CERTIFICATE OF APPROPRIATENESS

ITEM D16
HPO File #: HP2026_0067

415 Harvard
Houston Heights South

Proposal: Alteration – Garage addition

Side Wall Length and Insets (Addition and New Construction)

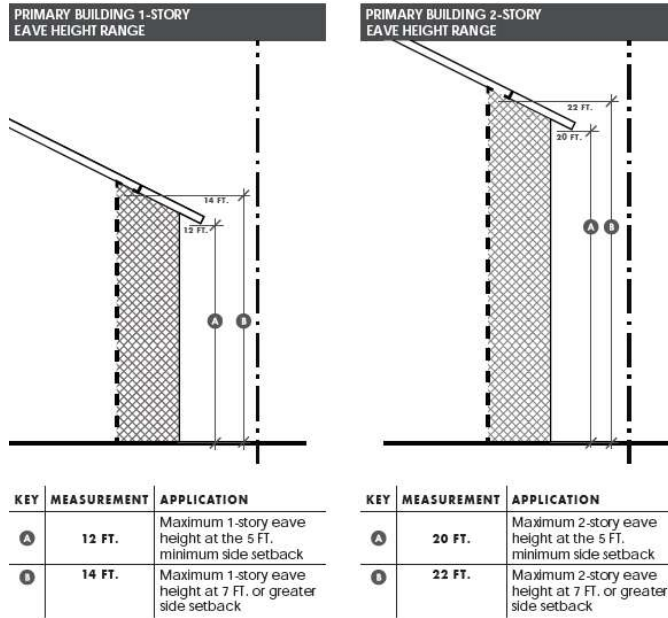
Side Wall Length: 40'-4" (existing)

Inset on (plan) North side: 6'-0"

Inset on (plan) South side: 17'-8"

Proposed side setback (North): 5'-6"

Proposed side setback (South): 20'-3"

Cumulative side setback: 25'-9"

Building Wall (Plate) Height (Addition and New Construction)

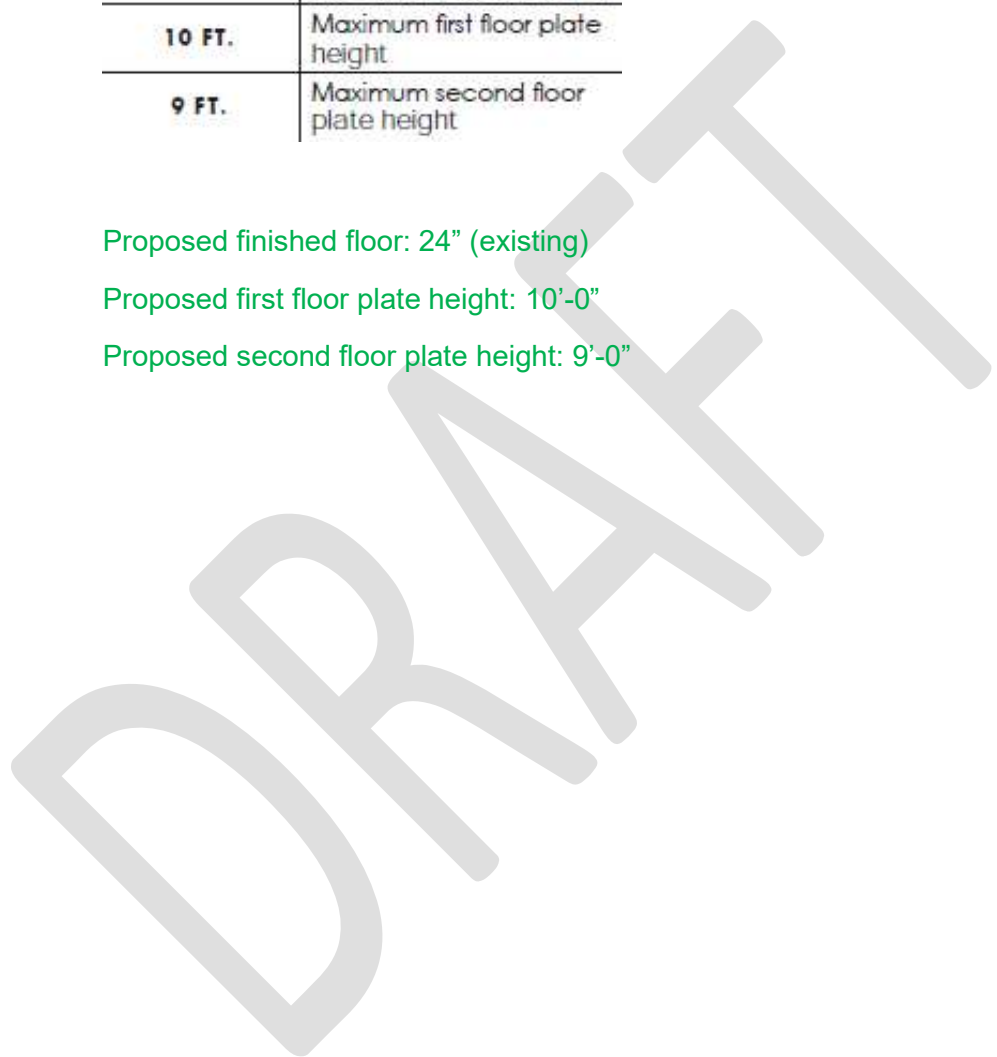
Proposed finished floor: 24" (existing)

Proposed first floor plate height: 10'-0"

Proposed second floor plate height: 9'-0"
